NEW MEXICO OIL CONSERVATION DIVISION
 - Engineering Bureau -
 1220 South St. Francis Drive, Santa Fe, NM 87505

CHAPARRAL 10 #1

RE: C-108, SWD APPLICATION
CHAPARRAL 10 #1– API#: 30-015-30229
Unit Letter "F" Section 10 T25S R28E
Eddy County, New Mexico

Injection Permit Checklist (11/15/2010)

PROPOSED

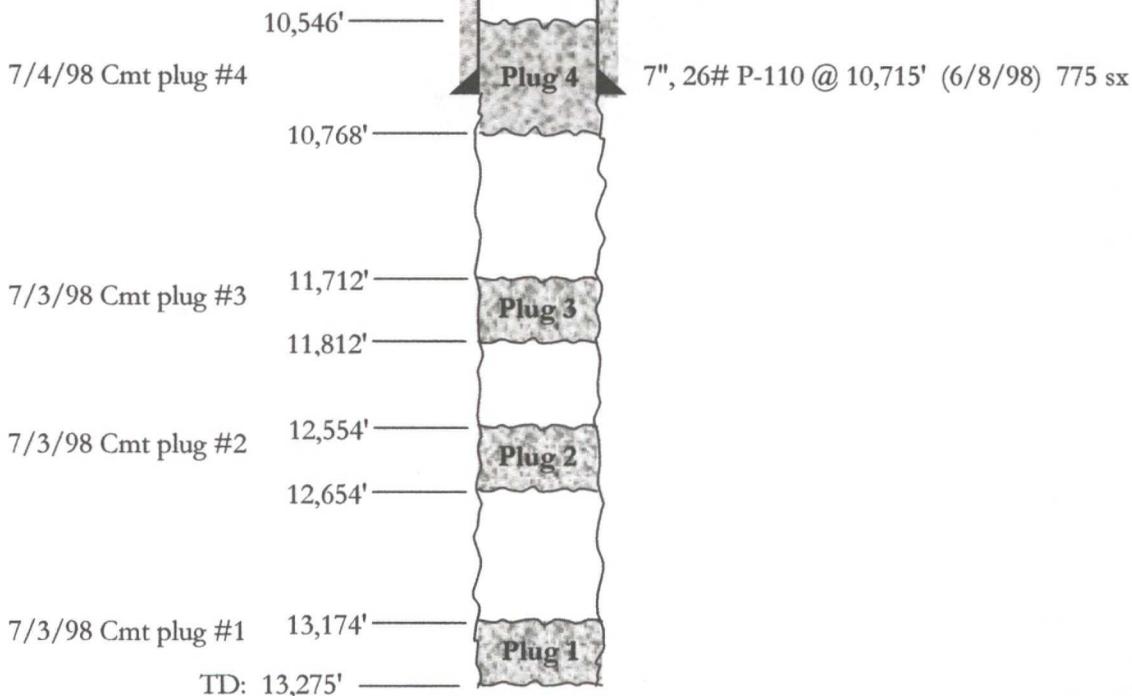
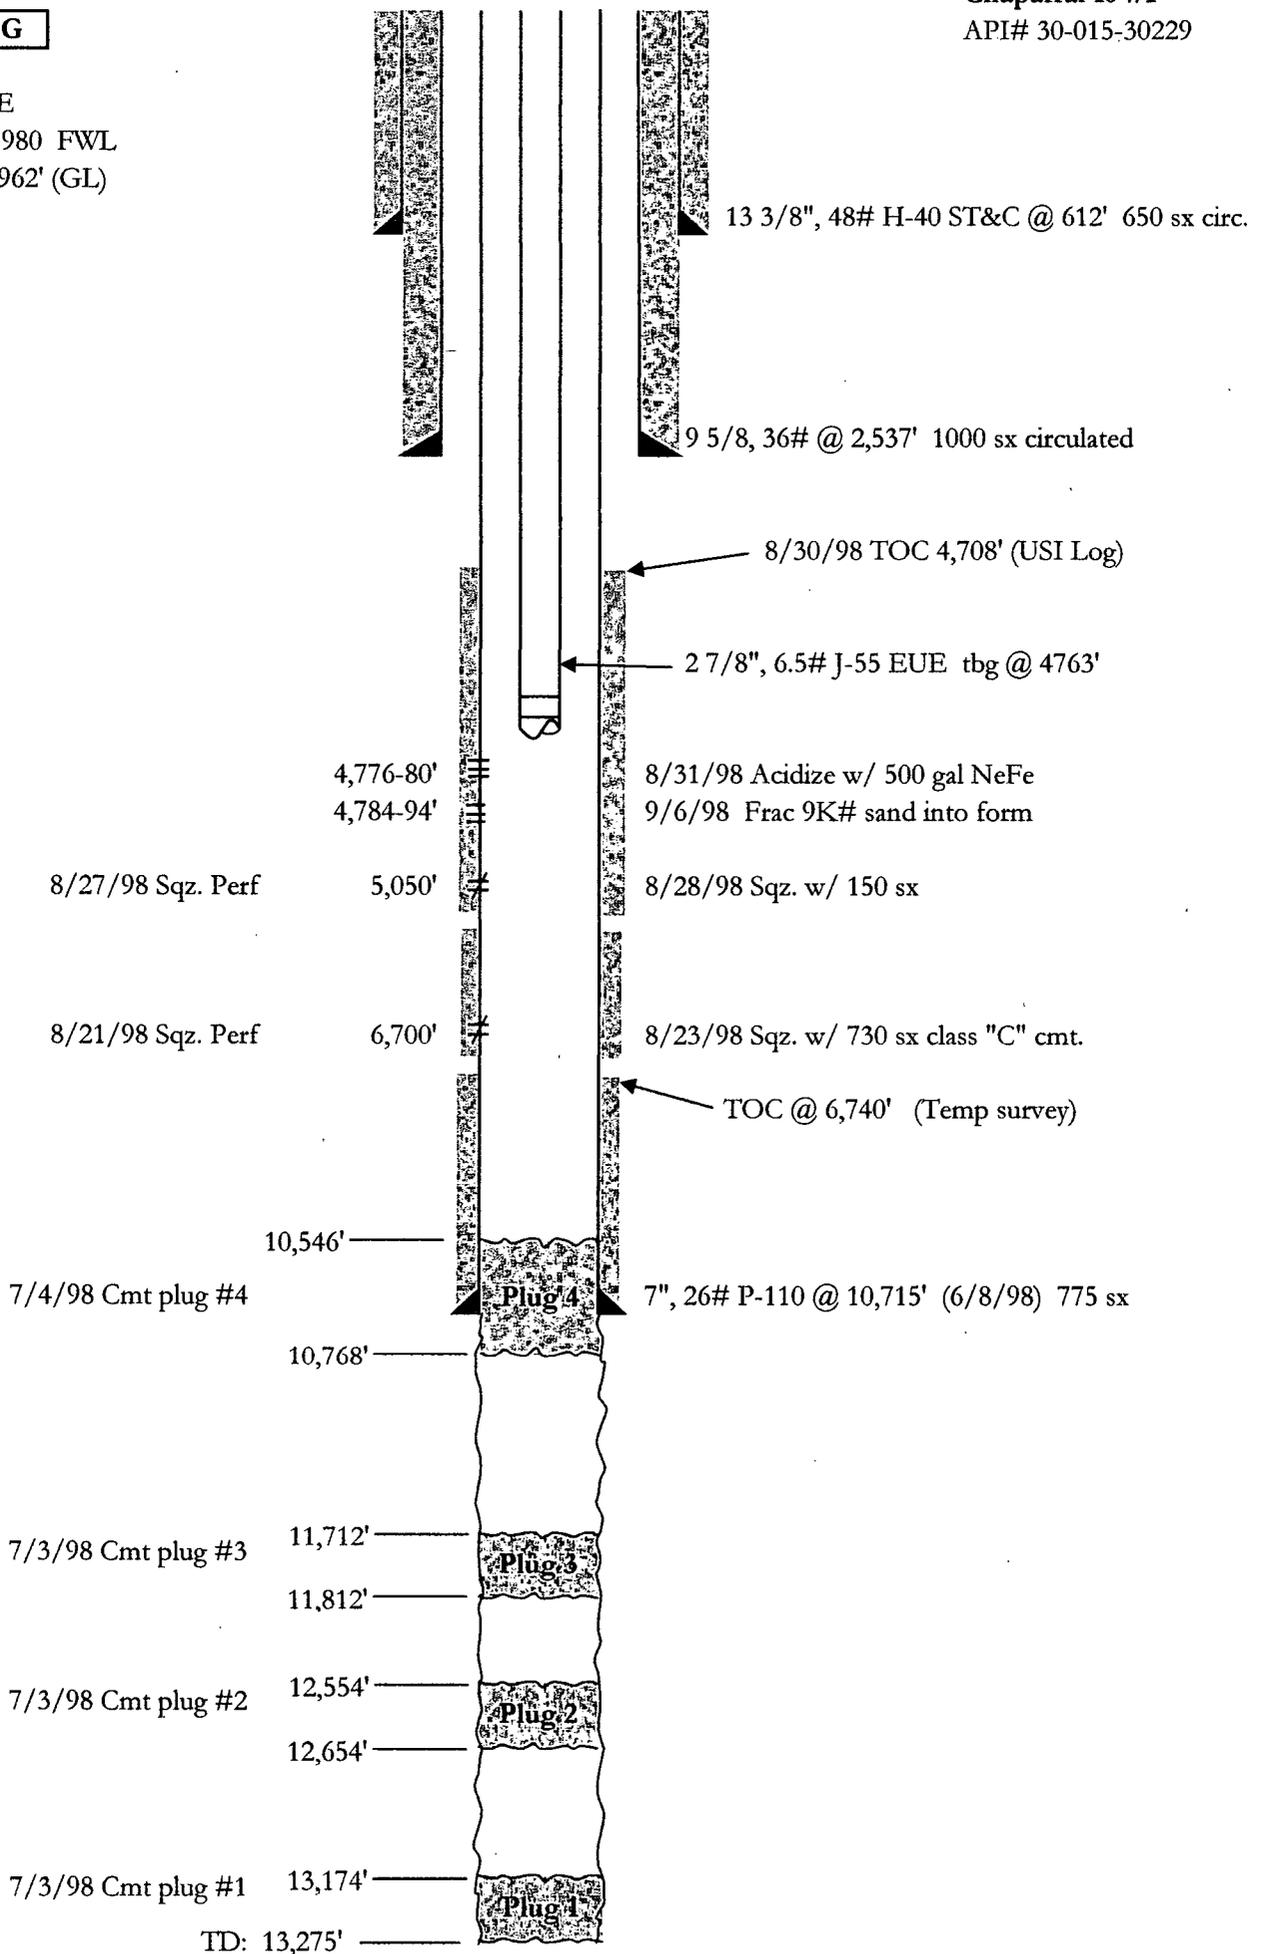
Issues: PB to 200' ± 6100' or c/o to 26100'
